**CDM: Proposed New Methodology
Meth Panel recommendation to the Executive Board**

<i>Date of Meth Panel meeting:</i>	19 - 23 October 2009
<i>Related F-CDM-NM document ID number (electronically available to EB members)</i>	F-CDM-NM0321: “Effective use of the waste gas emitted from ammonia production plant”
<i>Related F-CDM-NMex document ID number(s) (electronically available to EB members)</i>	F-CDM-NMex0321: Spalding-Fecher / Deodhar
<i>Related F-CDM-NMpu document ID number(s) (electronically available to EB members)</i>	F-CDM-NMpu0321: None received

**CLEAN DEVELOPMENT MECHANISM
PROPOSED NEW BASELINE AND MONITORING METHODOLOGIES
(CDM-NM)
(Version 03.1)**

This is the revised version of NM0321 reflecting the suggestions in the preliminary recommendation dated 23/10/2009.

Figure 1: Project Boundary

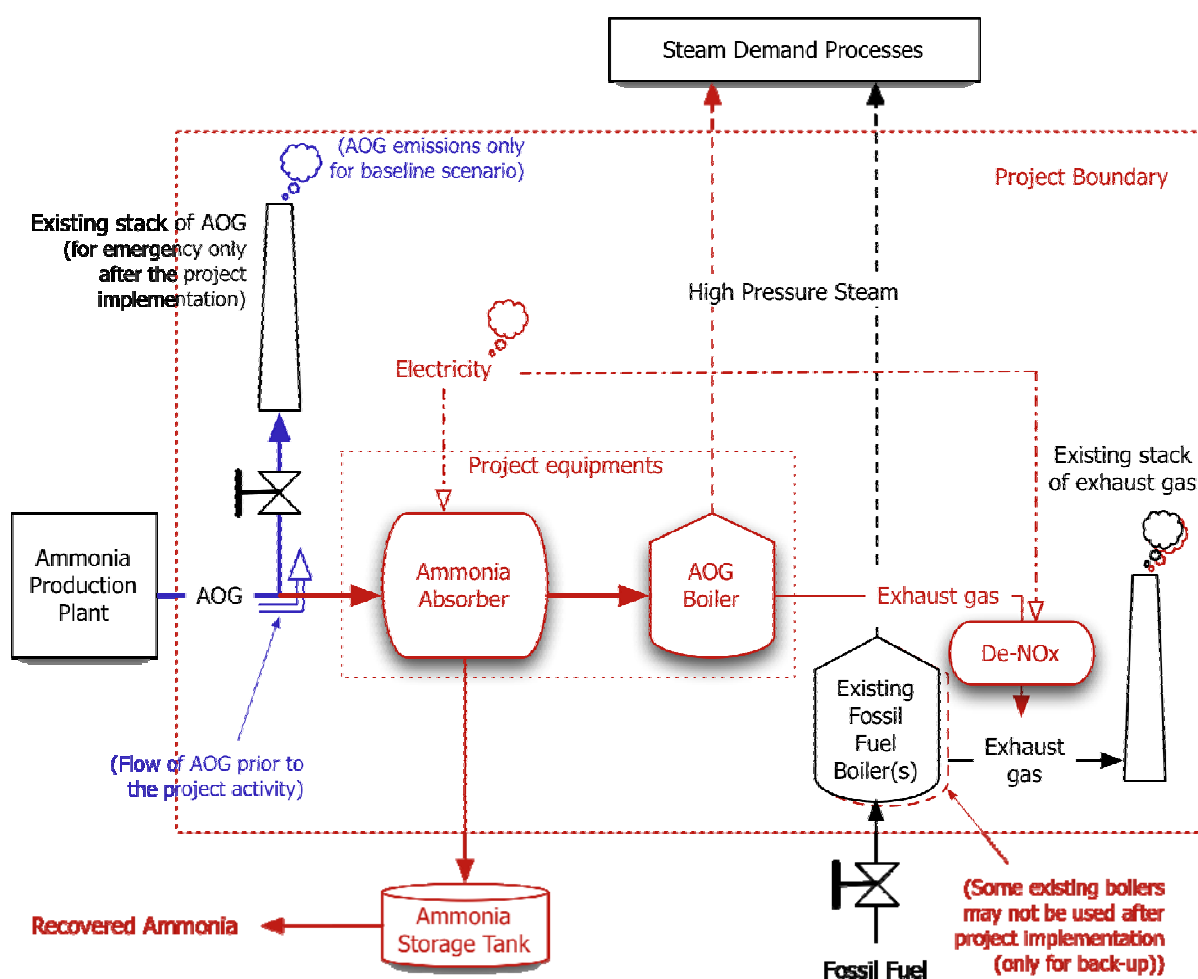
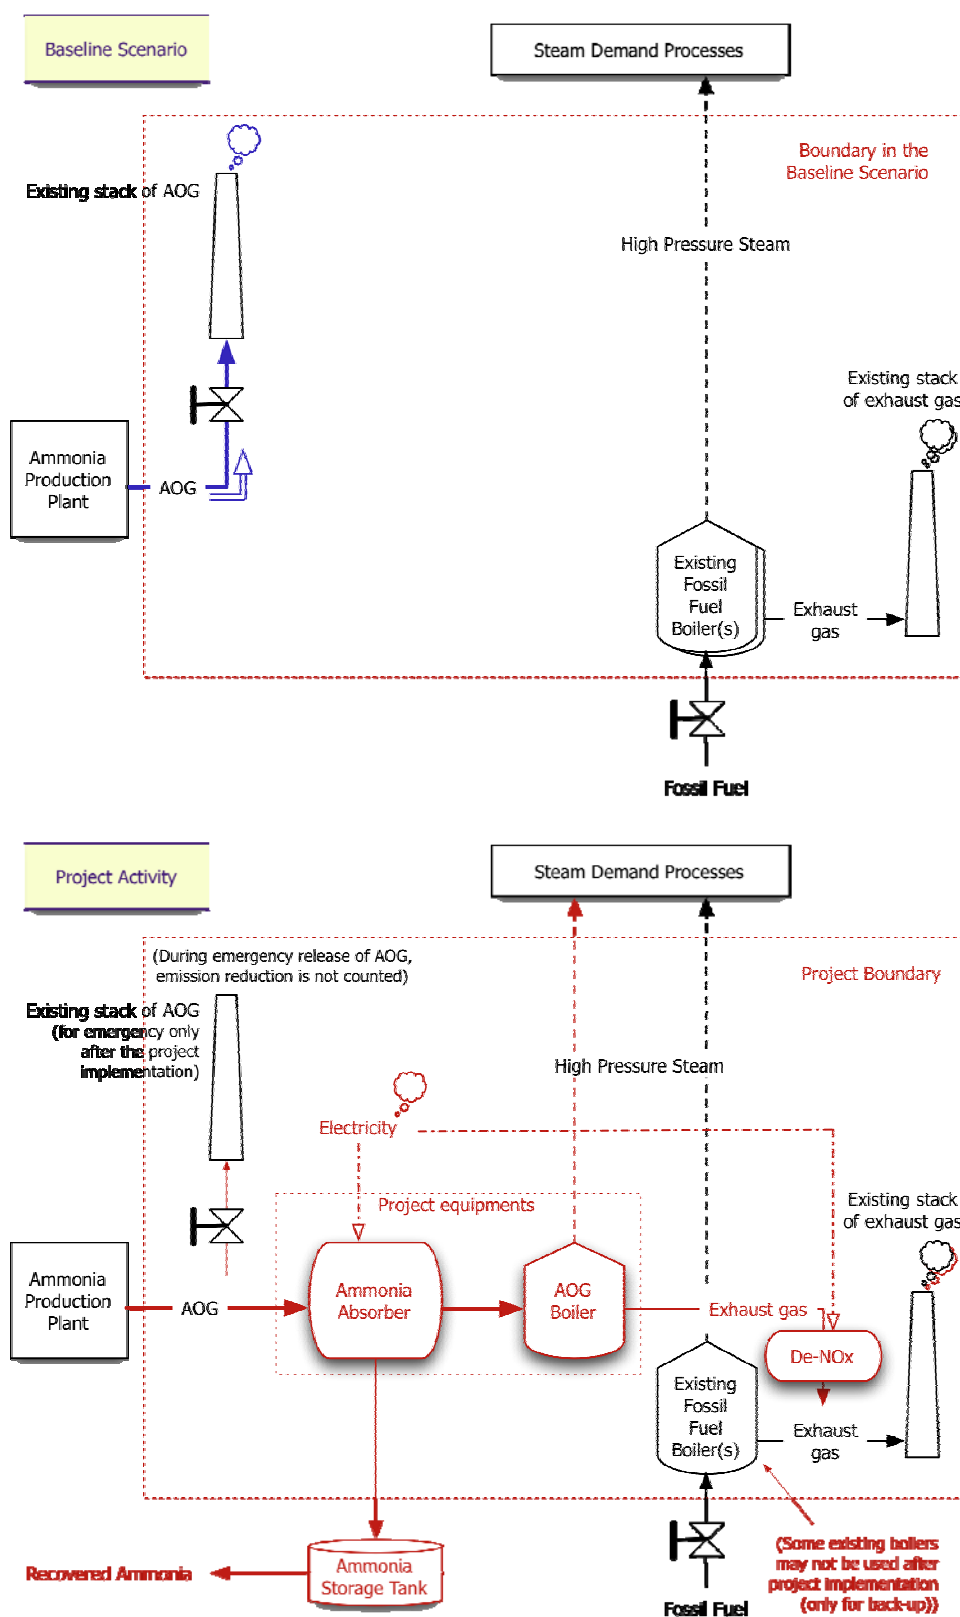
6. To improve clarity, diagrams of the baseline scenario and the project scenario would be useful.
 - *A diagram that combines both baseline scenario and project activity in one picture has been attached. An alternative, a set of two diagrams for baseline scenario and project activity separately, has been also inserted. Please choose whichever you like.*

- *The following explanation has been added as the first paragraph of the “project boundary” section: “The project aims to install equipment to collect all of the AOG (except for the case of emergency) and use it as a single fuel (not mixing with other fuels) for steam generation in a new boiler specifically designed for AOG. It replaces some existing boiler(s) which use(s) a fossil fuel (although the replaced one may be kept as it is for back-up purposes). In order to clean AOG, ammonia absorber and/or DeNOx equipment may be introduced to collect ammonia from it and/or to clean the exhaust gas as shown in Figure 1.” Some other technical aspects of ammonia production are described in the definition section (in the explanation of “AOG”).*
